### ADDENDUM 2

Project Name: Drumheller Downtown Dike Project #2023-03-28	
Date: April 12, 2023	
Item	Detail
<b>A2.1</b>	<p><b>Retaining Wall Package Updated</b></p> <p>The Retaining Wall Package has been updated and included in this Addendum as an attachment. It has been updated to include the dike chainage along the three different retaining walls. This was added to make it easier to reference when constructing the dike.</p>
<b>A2.2</b>	<p><b>Pre-Bid Meeting Question: Construction Schedule Dates</b></p> <p>Answer: There are still outstanding Regulatory Approvals required prior to construction starting on the Downtown Dike. For bidding purposes, Bidders are to assume that Construction can start on July 1, 2023. It is required that the park area behind the Badlands Community Facility (BCF) be completed by the end of 2023, including all landscaping and irrigation (station 0+350 to 0+550). Within the tender documents, it is stated that Substantial Performance must be November 15, 2023, DRFMO will accept bids that have construction finishing in 2024, however, preference will be given to proposals that finish construction in 2023.</p>

# DOWNTOWN DIKE REDI-ROCK RETAINING WALLS DESIGN

**TOWN OF DRUMHELLER**  
**DOWNTOWN DIKE**  
**AQUAPLEX, RIVERVIEW TERRACE, AND RIVERSIDE DRIVE**  
**REDI-ROCK RETAINING WALL DESIGN**  
**AQUAPLEX SITE PLAN**

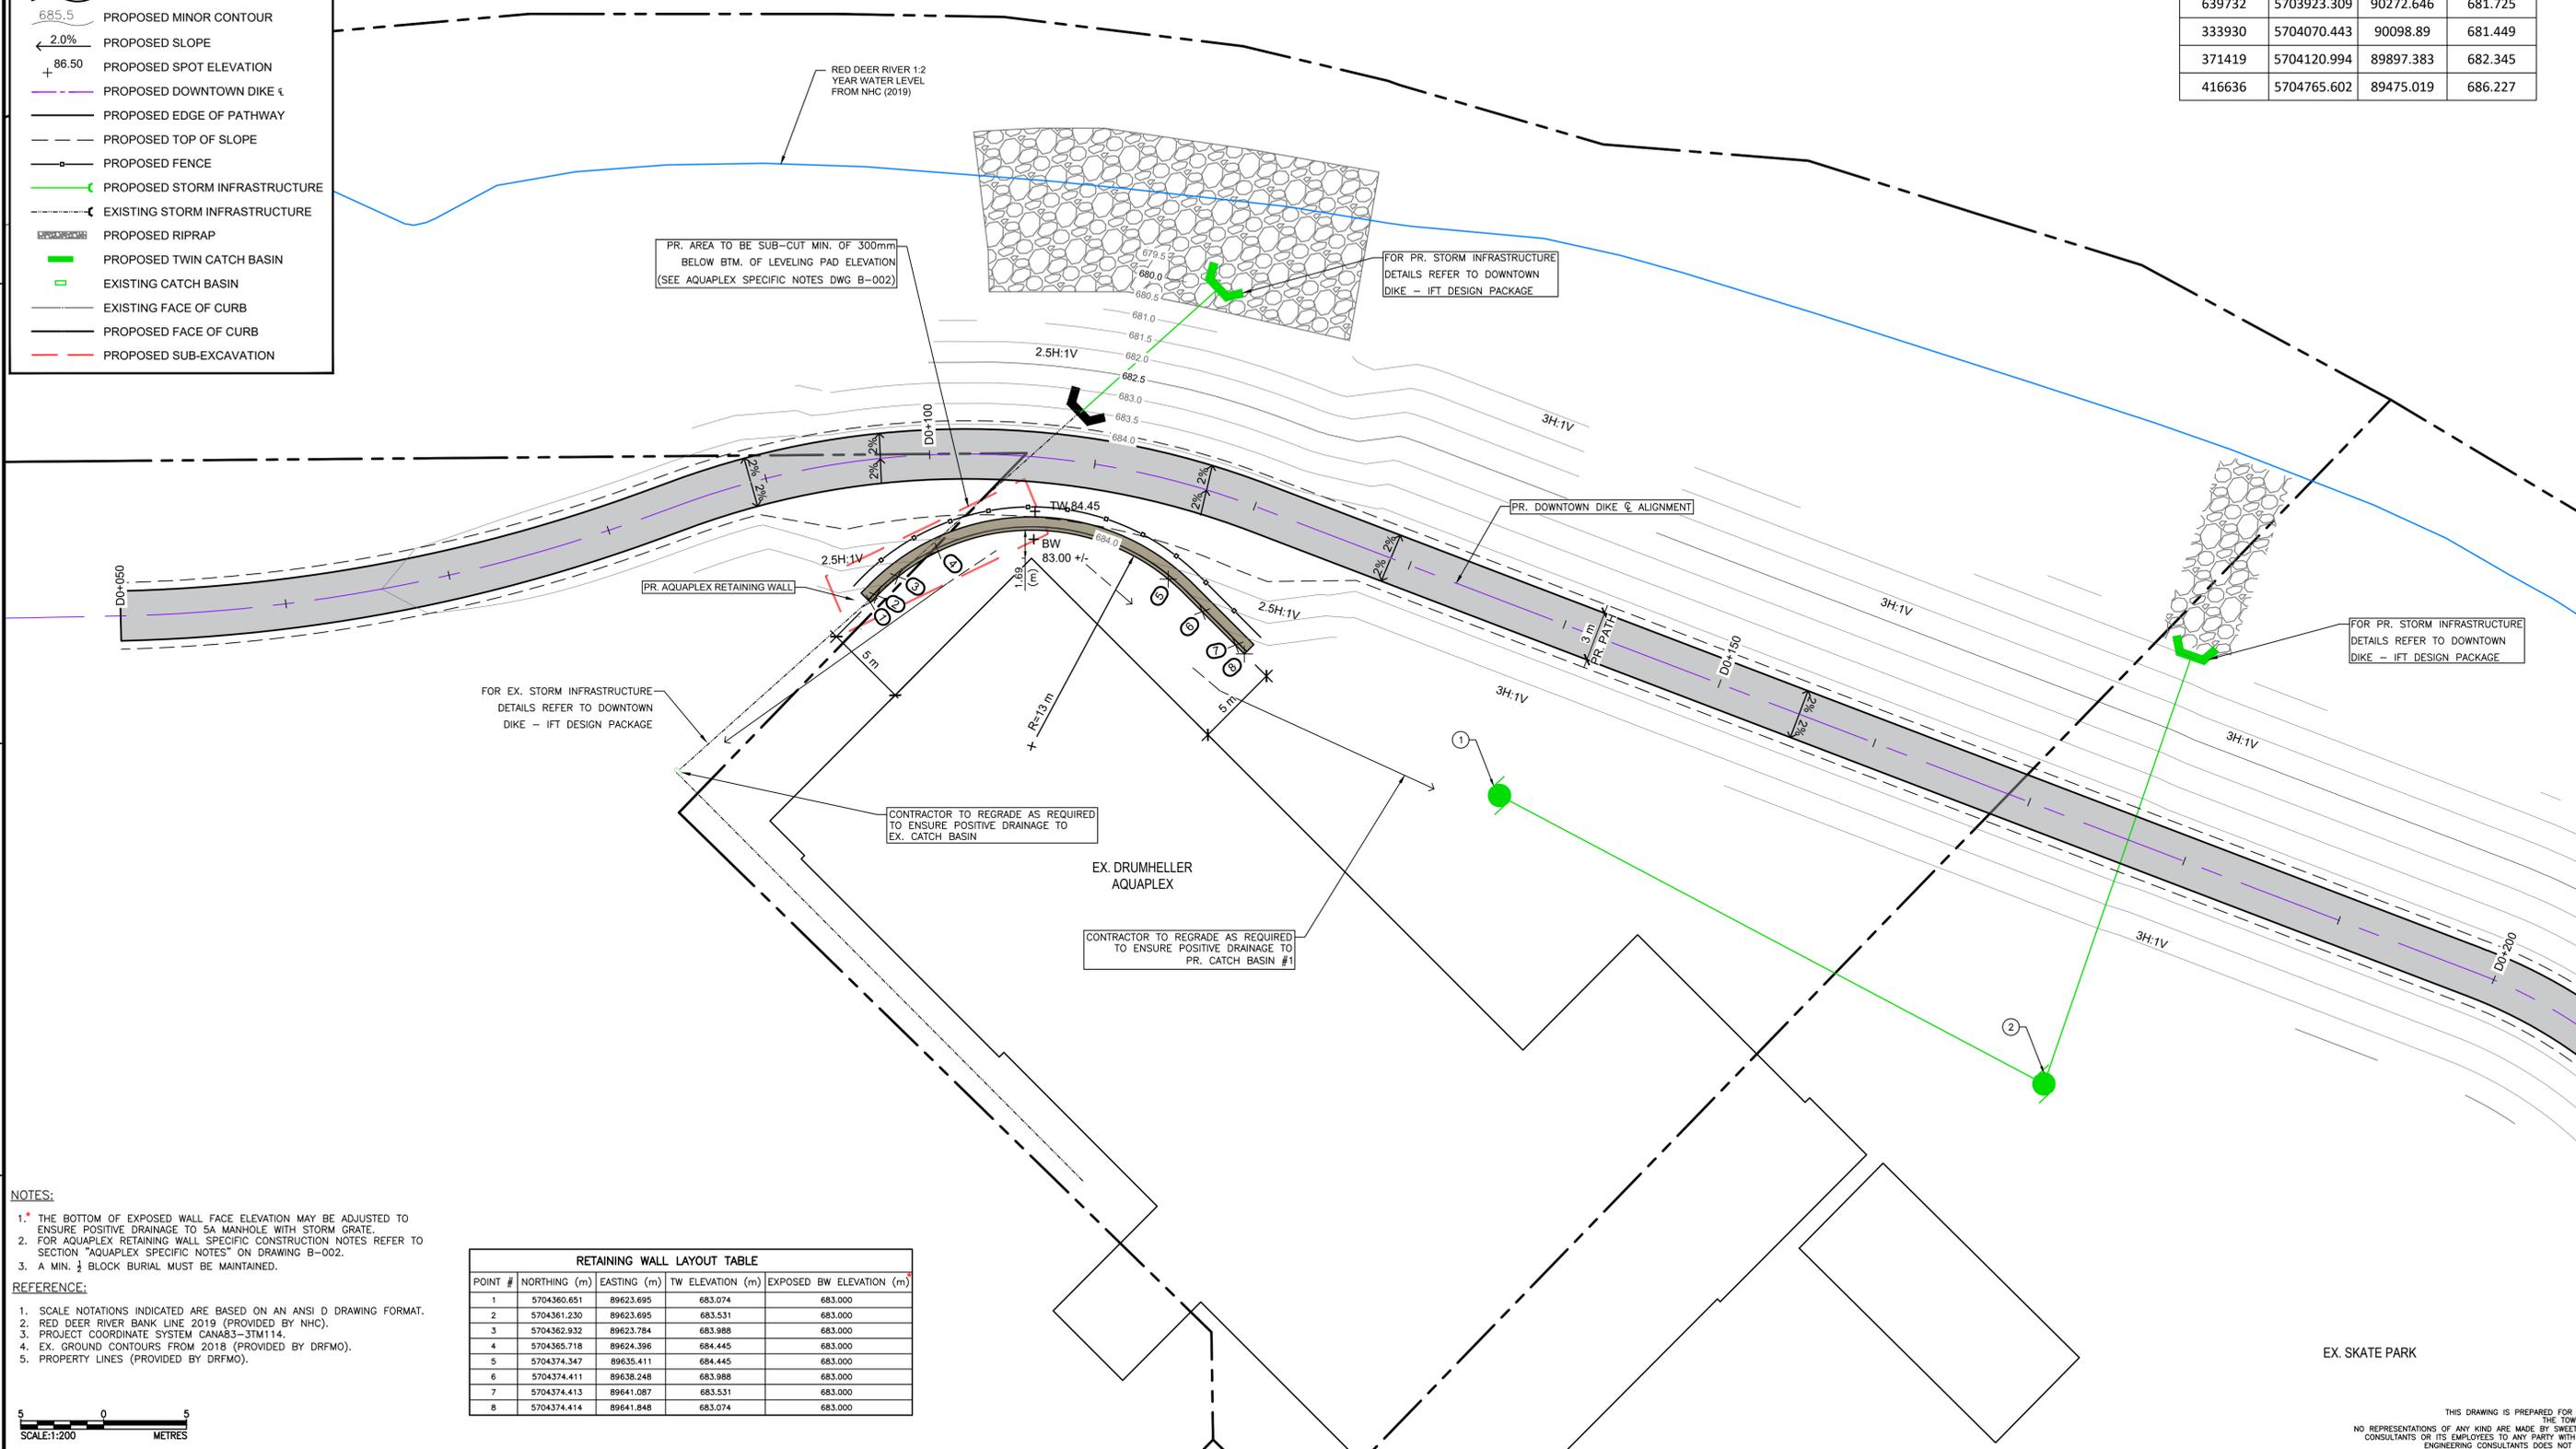
Rev	Date	Des	Dwn	Chk	Description
0	2023-03-20	AO	KS	AO	ISSUED FOR TENDER
1	2023-04-05	AO	KS	AO	ADDED DOWNTOWN DIKE ALIGNMENT & STATIONS

<b>TOWN OF DRUMHELLER</b>			
<b>DOWNTOWN DIKE</b>			
<b>AQUAPLEX, RIVERVIEW TERRACE, AND RIVERSIDE DRIVE</b>			
<b>REDI-ROCK RETAINING WALL DESIGN</b>			
<b>RIVERVIEW TERRACE SITE PLAN</b>			
Project No.	21.2311.002	Drawing No.	
Group	GEOTECHNICAL		
		<b>B-102</b>	<b>1</b>

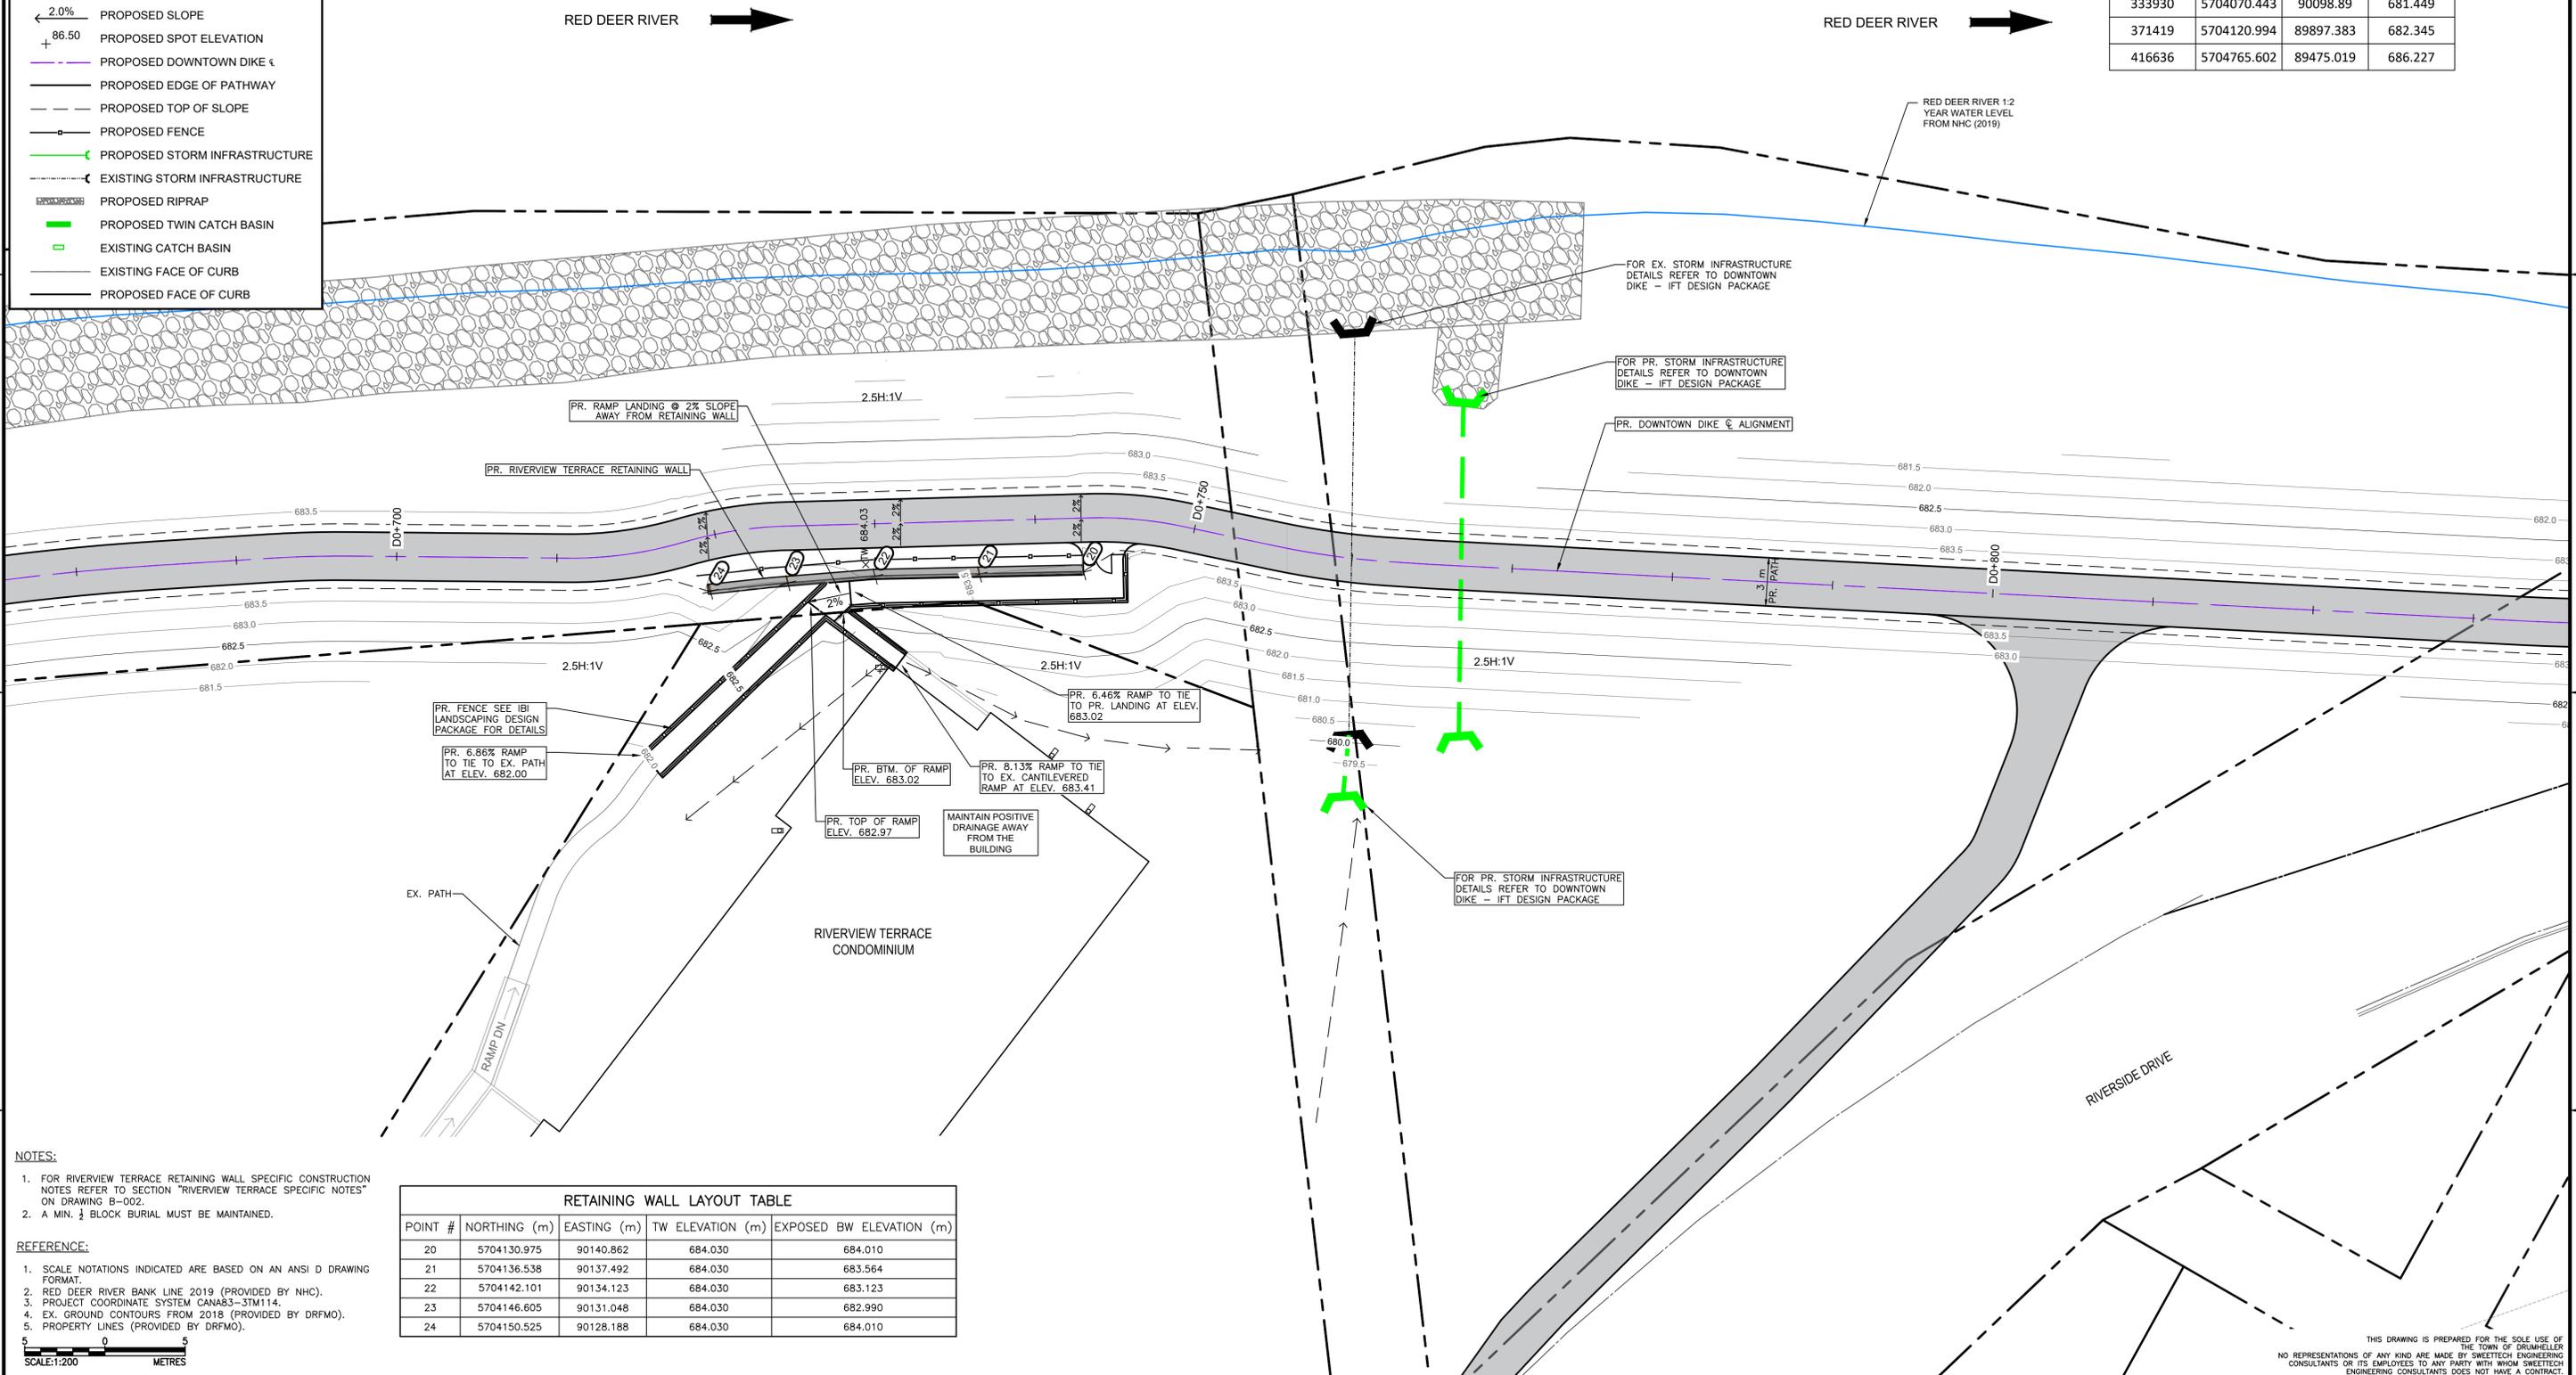
<p><b>PERMIT TO PRACTICE</b> 1963401 ALBERTA LTD. RW SIGNATURE: <i>[Signature]</i> RW APEGA ID #: 692442 DATE: 2023.03.25 2:45:23 <b>PERMIT NUMBER: P013638</b> The Association of Professional Engineers and Geoscientists of Alberta (APEGA)</p>	Rev	Date	Des	Dwn	Chk	Description	Rev	Date	Des	Dwn	Chk	Description
				0	2023-03-20	AO	KS	AO	ISSUED FOR TENDER						
				1	2023-04-05	AO	KS	AO	ADDED DOWNTOWN DIKE ALIGNMENT & STATIONS

**TOWN OF DRUMHELLER**  
**DOWNTOWN DIKE**  
**AQUAPLEX, RIVERVIEW TERRACE, AND RIVERSIDE DRIVE**  
**REDI-ROCK RETAINING WALL DESIGN**  
**RIVERSIDE DRIVE SITE PLAN**

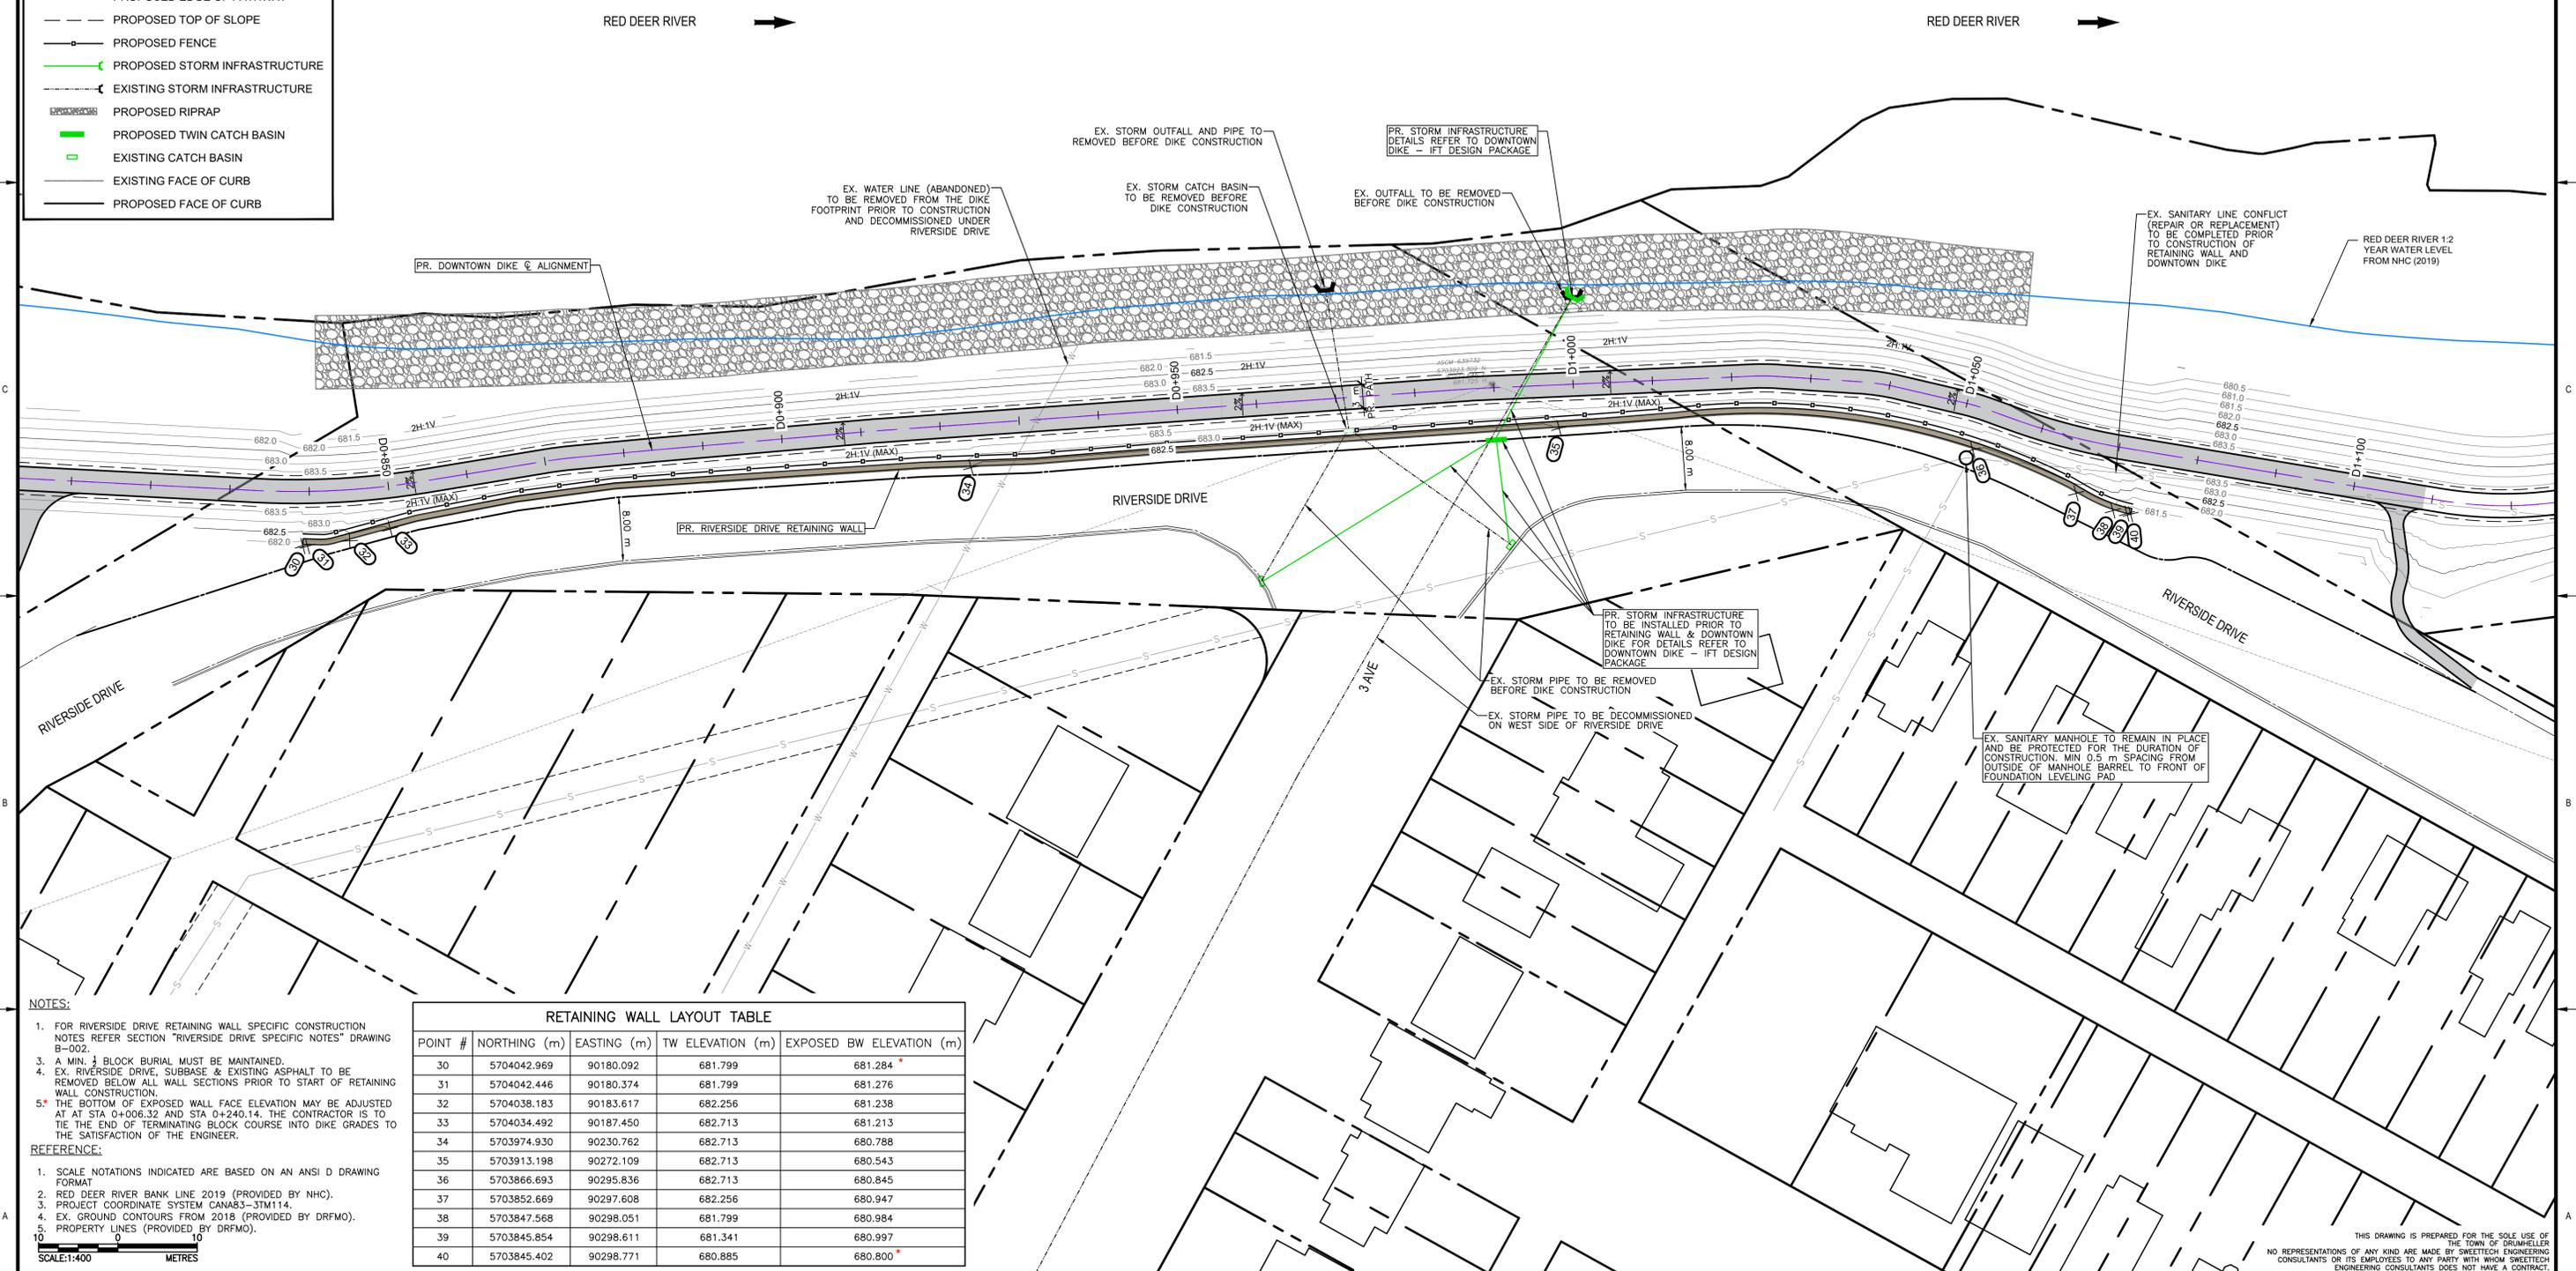
Rev	Date	Des	Dwn	Chk	Description
0	2023-03-20	AO	KS	AO	ISSUED FOR TENDER
1	2023-04-05	AO	KS	AO	ADDED DOWNTOWN DIKE ALIGNMENT & STATIONS
